**Project/File:** **Barber Mill Estates (CAR13-00007/ PUD13-00002/ SUB)**  
 This is an annexation, rezone, planned unit development, and preliminary plat application to subdivide approximately 12 acres into 47 residential lots and 10 common lots. The site is located at 5237 E Sawmill Way in Boise, Idaho.

**Lead Agency:** City of Boise

**Commission Hearing:** July 17, 2013  
*Regular Agenda*

PUD 13 - 00 00 2

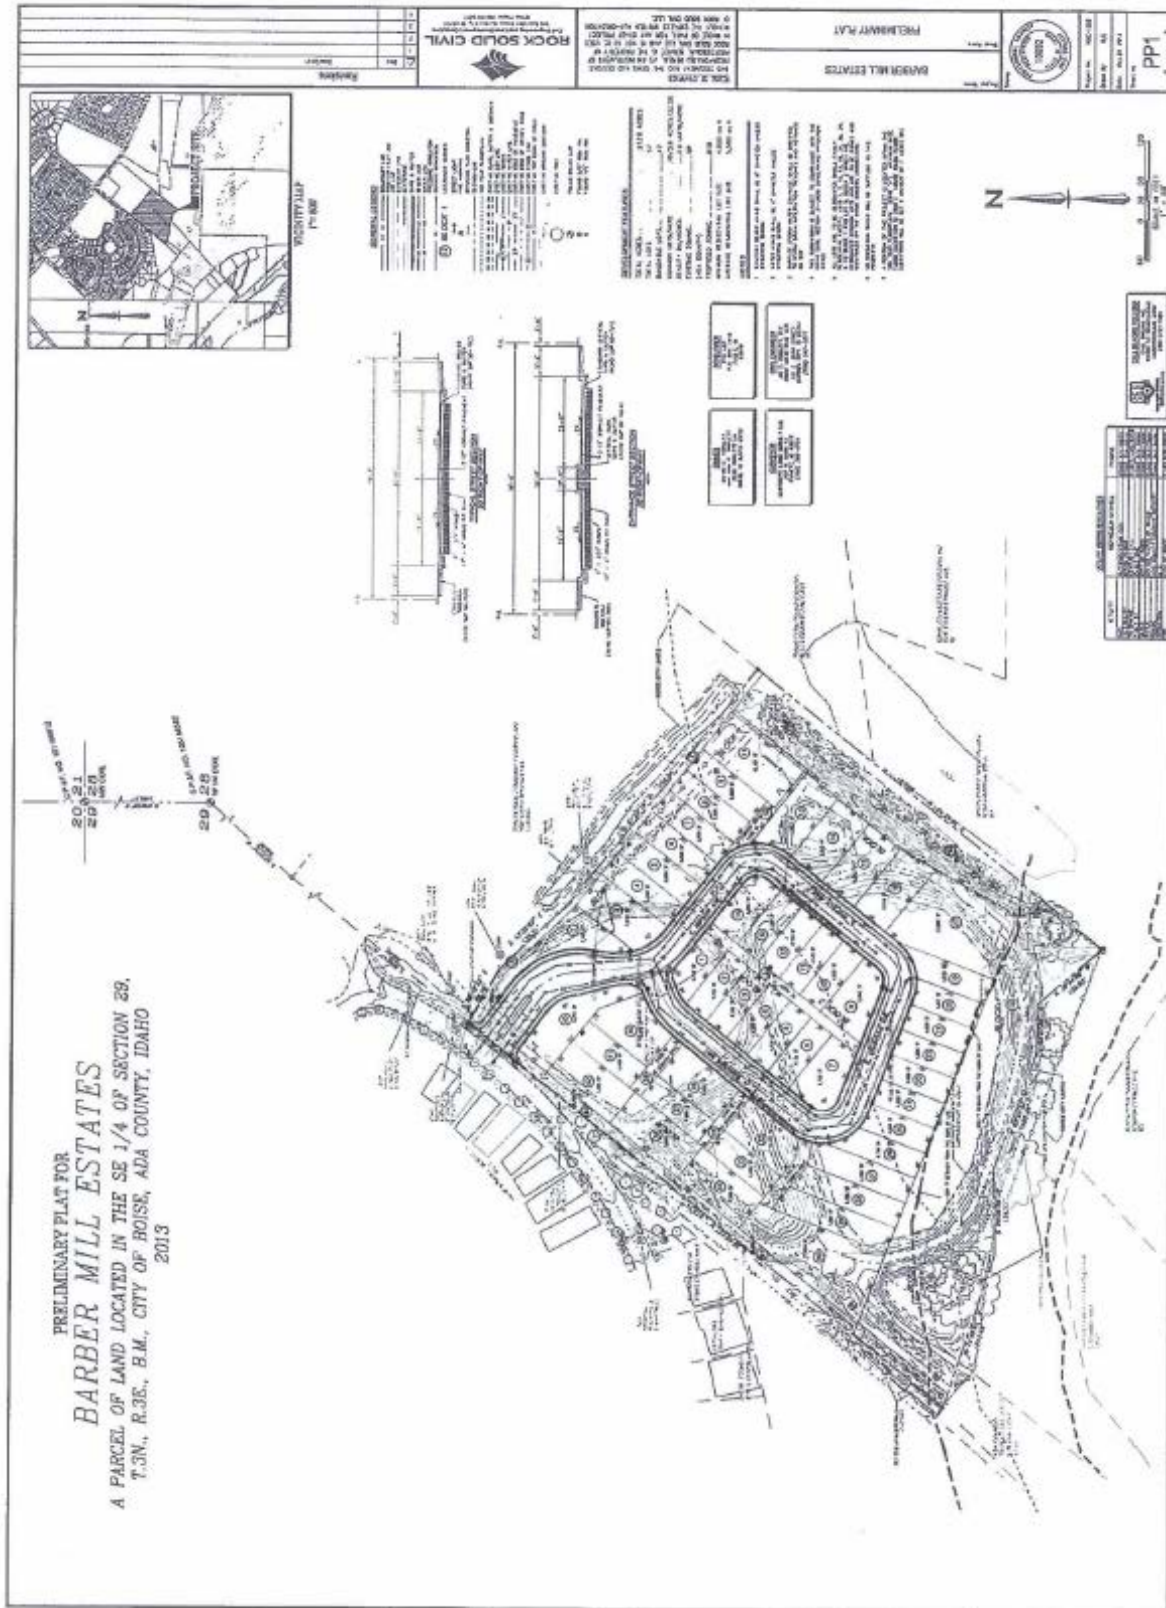
- d. **Staff Comments/Recommendations:** The applicant's proposal meets District Policy with the exception of the proposal to not construct a sidewalk on the north side of the roadway into the site. The applicant should be required to construct a 5 foot wide attached or detached concrete sidewalks on both sides of Ripsaw Avenue. The applicant should provide a permanent right-of-way easement for any sidewalks placed outside the dedicated right-of-way.

The applicant has proposed to construct 6.5 feet planter strips between back of curb and sidewalk. ACHD's Tree Planting Policy requires planter strips be a minimum of 8 feet wide for street trees or the installation of continuous root barrier.

2. Replace any broken curb, gutter or sidewalk and to update the pedestrian ramps on Sawmill Way, abutting the site.
3. Construct one entry road to intersect Sawmill Way, 240 feet south of Arrow Junction Drive, as a 29 foot street section with curb, gutter and 5 foot wide attached or detached concrete sidewalks on both sides of Ripsaw Avenue within 42 feet of right-of-way. Provide a permanent right-of-way easement for any segment of the sidewalk placed outside the dedicated right-of-way.

4. Construct all other internal local streets as proposed with 36 foot street sections with curb, gutter and 5 foot wide attached concrete sidewalks within 50 feet of right of way.

5. Construct one new 16 foot wide north/south alley within the site, as proposed. That alley is midblock and will run between Ripsaw and Chainsaw Avenues.
